Charlotte Department of Transportation

Memorandum

Subject: Rezoning Petition 13-101: Approximately 2.13 acres located on the east side of Valleydale Road, on the west side of Bellheaven Boulevard and across from the intersection of Coulwood Drive and Valleydale Road.

Figure 1: Valleydale Typical Section

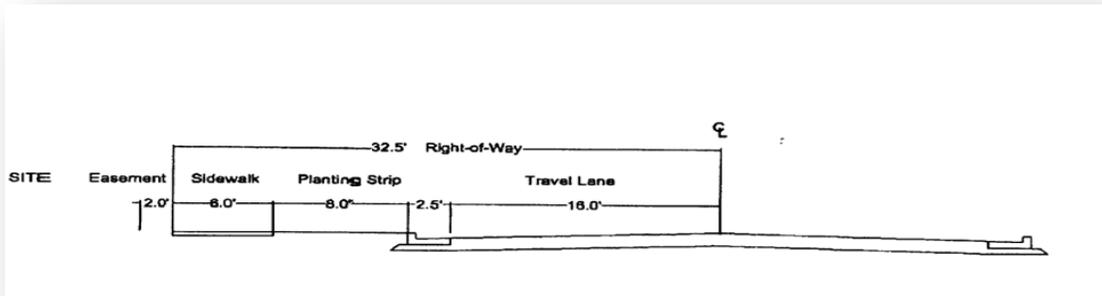
2. CDOT understands curb and gutter will be required along the site's frontage on Valleydale Road by Chapter 19 of the City Code. Valleydale Road's typical street section requires two (2) 11-foot travel lanes, two (2) five-foot bike lanes, two (2) 2.5-foot curb and gutter sections in addition to an 8' planting strip and 6' sidewalk along both sides of the street. As such, we request the petitioner locate the back of curb 18.5 feet measured from the existing Valleydale Road centerline along the site's frontage (see Figure 1).
